ORDINANCE NO. 1769

AN ORDINANCE AMENDING ORDINANCE NO. 1253 KNOWN AS THE ZONING ORDINANCE TO AMEND ORDINANCE NO. 1317: A PLANNED UNIT DEVELOPMENT KNOWN AS FLY CREEK; AND TO FURTHER AMEND ORDINANCE 1572; TO APPROVE A REVISED MASTER PLAN; PROVIDING A SEVERABILITY CLAUSE; AND PROVIDING AN EFFECTIVE DATE.

DATE: January 13, 2023
TO: Fairhope City Council
FROM: Hunter Simmons, Planning Director
RE: Proposed Amendments to Fly Creek PUD ZC 22.14

ZC 22.14 - Fly Creek PUD Amendment

Figure 2: Lot 6D

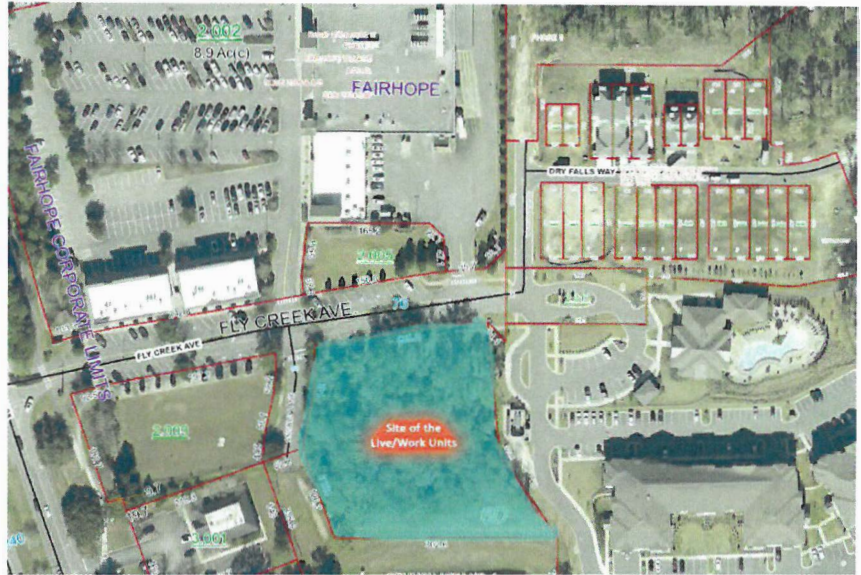
The original PUD approved in 2006 created a diverse mix of residential, as well as commercial components. Live/Work was a labeled use, but not clearly defined. As verbally described, it was intended to be residential on top of commercial units. The 2016 PUD amendment altered the layout of the apartments/townhomes, but did not approve a change in the use of the live/work units circled in Figure 1.

In 2019, the layout of 77 townhomes were refined in a MOP that did not include the live/work units. Figure 2 illustrates the live/work site (Lot 6D) in relation to current buildings.

Fly Creek Avenue was originally approved with a mix of uses that transitioned from commercial to residential as one moves further from Greeno Rd. The two existing buildings adjacent to Fly Creek Drive are commercial with no residential components. Work/live units at the site highlighted in Figure 2 support this transition and Staff typically recommends mixed-use within Village Centers.

Changes in use, especially from mixed-use to residential, should be considered carefully. Commercial components of a Village Center not only provide gathering places for residents and visitors alike, but also provide a tax base for the City. However, the Comprehensive Plan does recognize the City needs to be flexible to market conditions, which is the reasoning behind the Applicant’s request. Work/Live Units are not clearly defined within this PUD, nor within Zoning Ordinance. Therefore, it is difficult to evaluate this request.

Although we are not developers, Staff feels converting the units on Lot 6D to solely residential is a missed opportunity. While work/live may be impractical, alternatives, such as commercial below and residential units above may be successful. For example, a restaurant/watering hole on the ground floor can be a gathering place for residents and commercial tenants alike. The Applicant stated there are still vacancies at the Shoppes at Fairhope Village. A restaurant could be an economic driver offering reciprocal benefits to all property owners within the PUD. Staff would request the Applicant consider alternatives on Lot 6D.

Figure 3

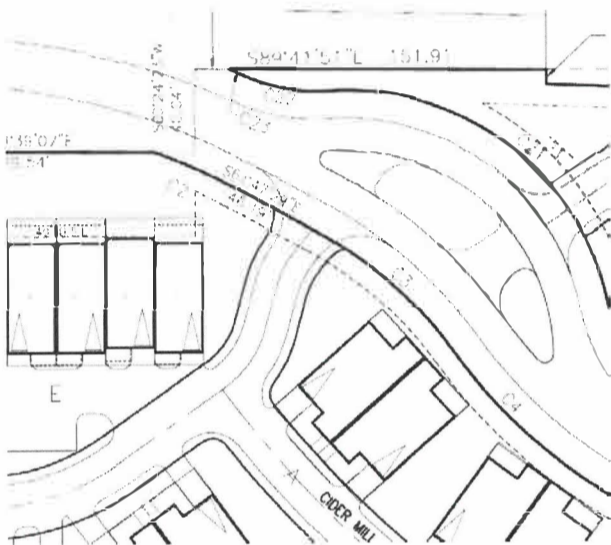
In general, Staff believes the deviations from the approved road layout are minor and further believes the proposed changes meet the intent(s) of the PUD. With that in mind, the addition of Cider Mill Lane alters the view of the townhomes fronting Corte Ridge Road. The elevations provided illustrate the view from Cider Mill Lane. Care should be given to the rear elevations of these units as they impact the visual aesthetic of a City maintained road.

In addition, Bascom Way was slightly altered at the intersection of Corte Ridge Road with proposed changes to the installed planting islands (Figure 3). With the addition of Cider Mill Lane, residents can easily access Corte Ridge Road from Dry Falls Way. Staff does not support further alteration of the existing planting islands (Figure 4).

This Amendment has been partially abandoned as the addition of a new interior road was eliminated. Updated reconfiguration of existing road(s) does not interfere with the existing landscaped traffic island on Corte Ridge Road, which was a concern. Moreover, the reconfiguration yields better parking and also satisfies a tight setback. Exhibit A is the most up-to-date site plan, which varies slightly from the plan reviewed by the Planning Commission.

Figure 6: Site Plan as currently approved (2019)

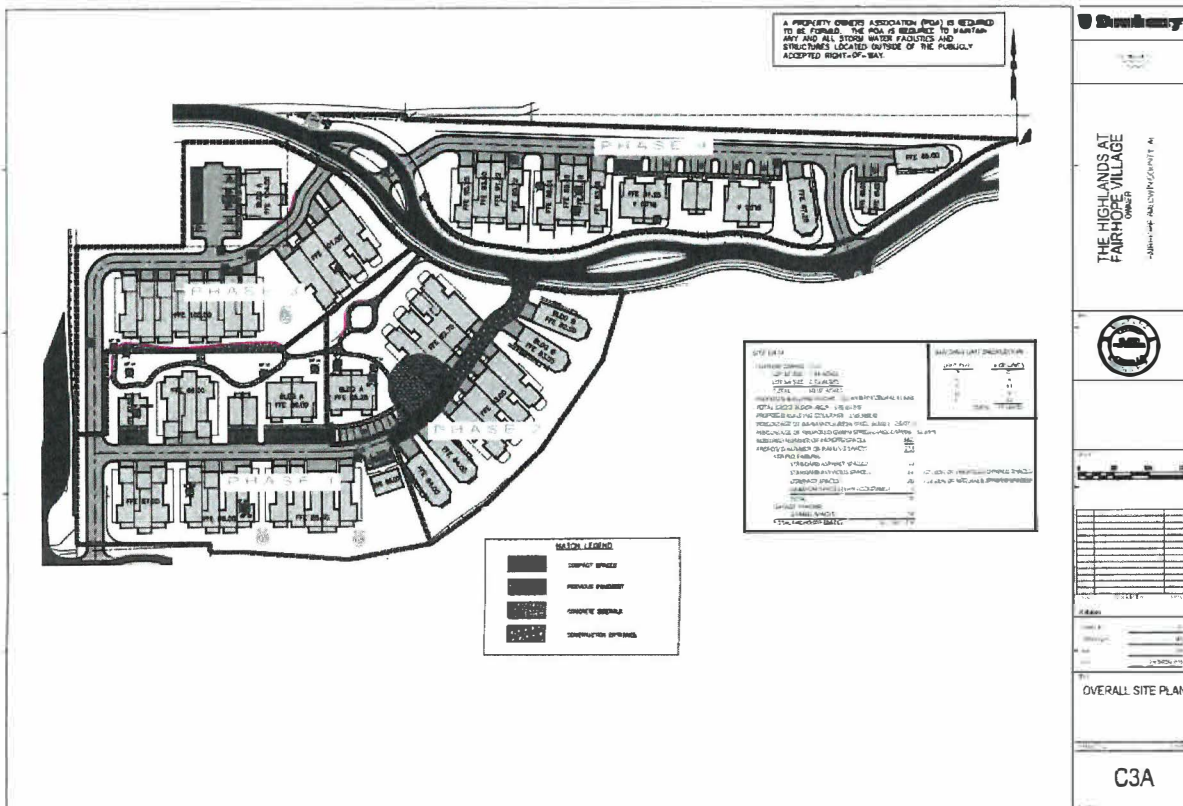
The site plan approved in 2019 (Figure 6) consists of 77 units mixed within five (5) different building types as shown in the Site Data Table (Figure 5).

174 Parking spaces were provided in total. 42.16% of the site was greenspace and 28.97% was impervious surface (excluding buildings). Gross Density was 7.65 Units/Acre.

Figure 10

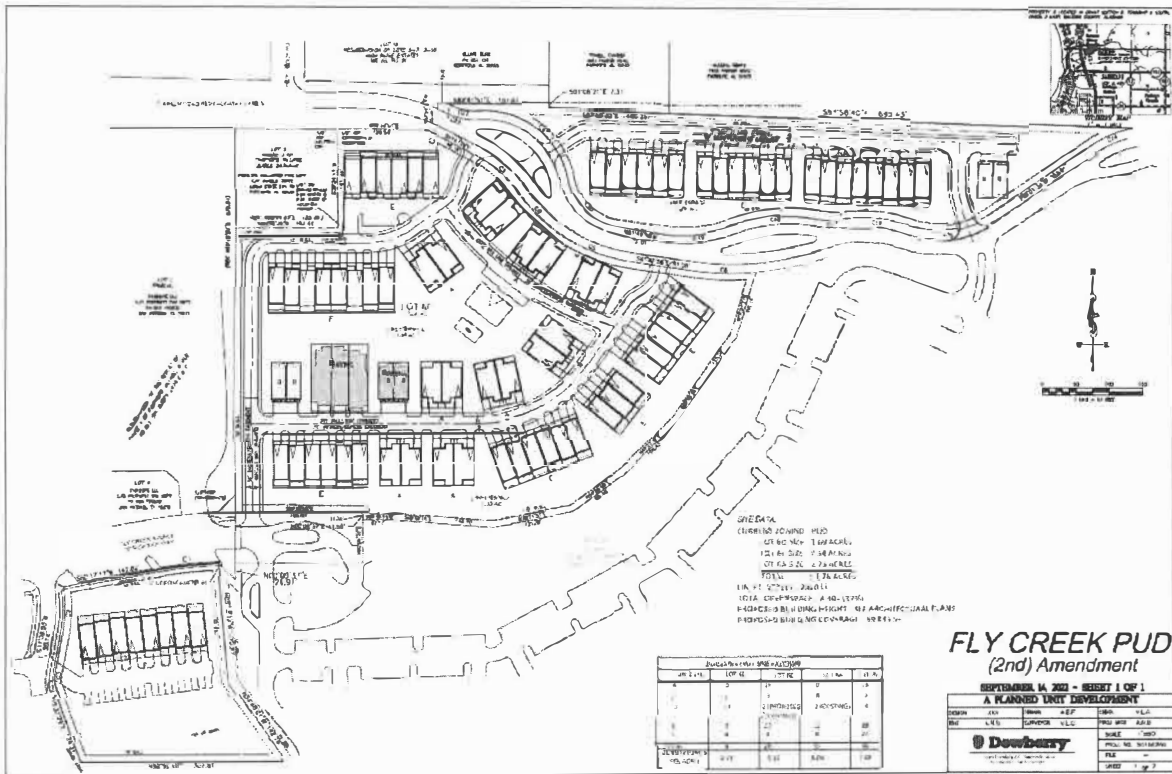
There are two (2) site plans submitted with this application: Figure 10 does not illustrate sidewalk/trails, but does include a pool and clubhouse adjacent to the newly proposed Cider Mill Lane. Figure 11 is a rendered site plan illustrating a different location of the pool/clubhouse. A schematic pedestrian path is shown in Figure 11.

In addition to the amendments proposed, a PUD includes approval of a site plan. Since Planning Commission is making a recommendation to the City Council on this case, Staff recommends review comments in this staff report, as well as comments from Commissioners during the October 3 Planning Commission, be incorporated into a single site plan prior to presenting to the City Council.

It is important to note, neither plan clearly defines pedestrian connectivity throughout the site, nor with the surrounding components of the PUD. A pedestrian circulation plan shall be required with the MOP for review.

- 1.) Buildings shall fall within established setbacks and allow room for required landscape/buffers.
- 2.) A formal Site Plan/Multiple Occupancy Project shall be conducted.
- 3.) Detailed floor plans shall be provided for each building type with front/rear elevations with particular focus on the rear of buildings located along Corte Ridge Road.
